ACCESS AUDIT IN THE BUILT ENVIRONMENT 2014

WORKSHOP REPORT

Audited Venue: Blok F, JKR

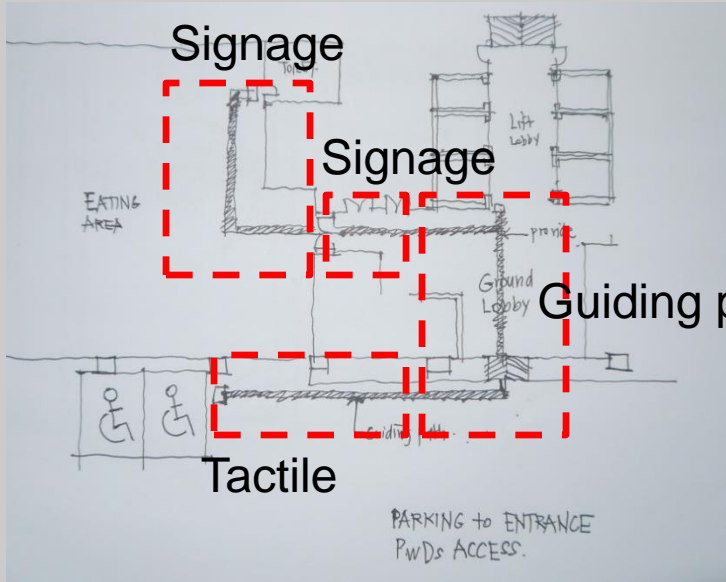
NO	ELEMENT	ANALYSIS	PROPOSAL
1	<p>PARKING</p>  	<ol style="list-style-type: none"> Current parking size is 3500 x 5000mm No wheel stopper Imprinted symbol indicated but no vertical signboard OKU parking located more than 3300mm from entrance 	<ul style="list-style-type: none"> - Parking size should be in accordance with MS 1184: 2014 (3600 x 5400mm) - To add wheel stopper - To add vertical signboard   <p>Vertical signboard</p> <p>PARKING to ENTRANCE PwDs ACCESS.</p>

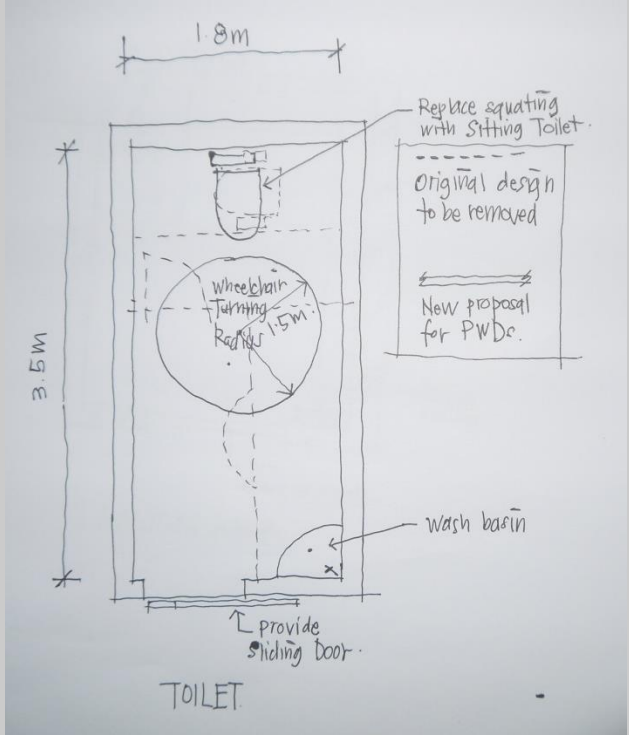
NO	ELEMENT	ANALYSIS	PROPOSAL
4	RECEPTION AND INFORMATION COUNTER  	<ol style="list-style-type: none">1. Countertop not suitable for disabled. The height is 1050mm2. No waiting area3. Obstruction on walkway	<ul style="list-style-type: none">- Provide staff assistance- The height of counter should be between 740mm to 800mm See MS 1184 cl.19.4- Clear knee space underneath counter shall be minimum of 700mm- To provide- To remove the obstruction

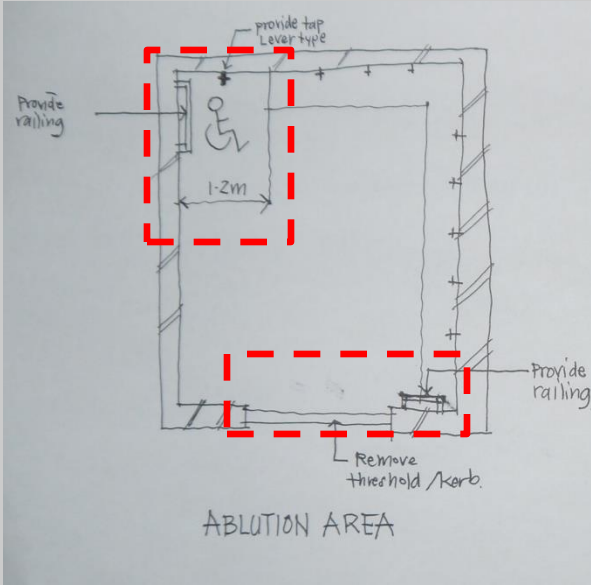
NO	ELEMENT	ANALYSIS	PROPOSAL
5	EATING AREA  	<ol style="list-style-type: none">1. Eating area is accessible to People with Disabilities (PwDs)2. Cash and service counter not suitable for PwDs3. Tables with loose chairs – easily accessible4. Handwash basin accessible	<ul style="list-style-type: none">- Provide assistance from cafe helpers

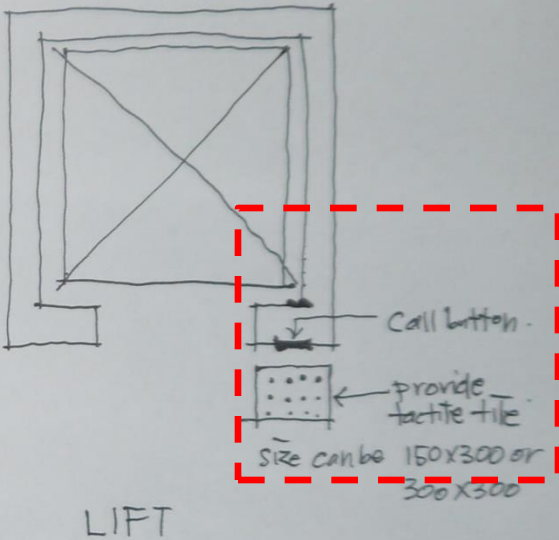
NO	ELEMENT	ANALYSIS	PROPOSAL
7	<p>SURAU</p> 	<ol style="list-style-type: none">1. Kerb at the entrance to ablution area2. No railing hook and concrete stool3. Slippery surface at ablution area	<ul style="list-style-type: none">- To remove threshold/ kerb-To provide railing hook and concrete stool  <ul style="list-style-type: none">- To provide rubber matt
